1993
Satellite Receiver
Also Covers
Pace PSR 910/914
Philips STU 804
Manhattan SR 95
Apollo SR 1900
Televes RST 200

Pace MRD 950/955

LATE CHANGES

Replacment of the U2 Extension PCB by U2

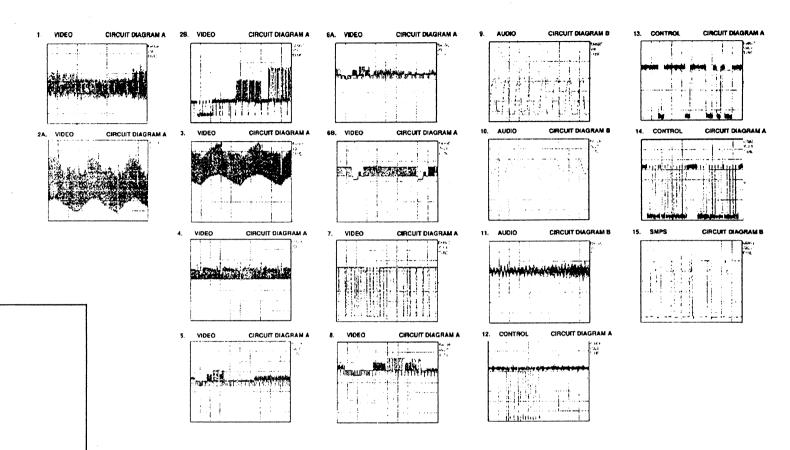
As of 21.11.92, ECOs 0000344, S000029 and S000036 should come into effect. These detail the substitution of the U2 extension PCB by the dedicated microprocessor U2 (8661 Proc PSR Ser - Part no. 809-8661003). At the same time, crystal X1 will need to move back onto the main PCB, and the following capacitors re-fitted:

*C32 (SMD 33 pF 50V 5% Cer Cog Cap - Part no. 950-3305501); *C33 (SMD 22 pF 50V 5% Cer Cog Cap - Part no. 950-2205501).

On single input receivers, the IC U6 will need to change to Cat 24C08 8k-Bit serial EPROM - Part no. 104-0240802.

In addition, the U4 extension PCB will need to be fitted.

Later still, the IC U2 will change to the following: 8661 Proc PSR Ser Part no. 809-8661007. Once this version of U2 is fitted, the U4 extension PCB will no longer be required and U4 will once again be mounted directly onto the main PCB.

OTHER CHANGES

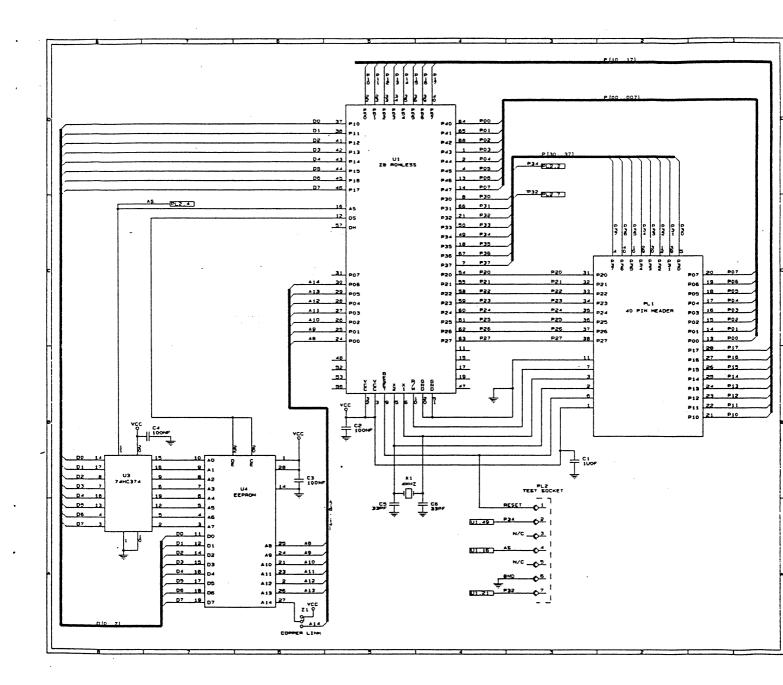
* As of 13.11.92, C10 will become an SMD 47 nF 50 V 10% Cer X7R Cap 0805 - Part no. 950-4735621 because of supply difficulties with the original part (PCO S000005).

As of 10.11.92, video processing IC U9 will change from Version 2FS to Version 2 (Part no. 109-0960102) as detailed in ECO 000397.

As of 6.11.92, adjustable coils L15, L16 and L27 will become 10.7 MHz 3% Adj coil type FH-7 Part no. 133-2868704; as thes include a capacitor, C304, C305 and C306 will no longer be fitted (PCO S000001).
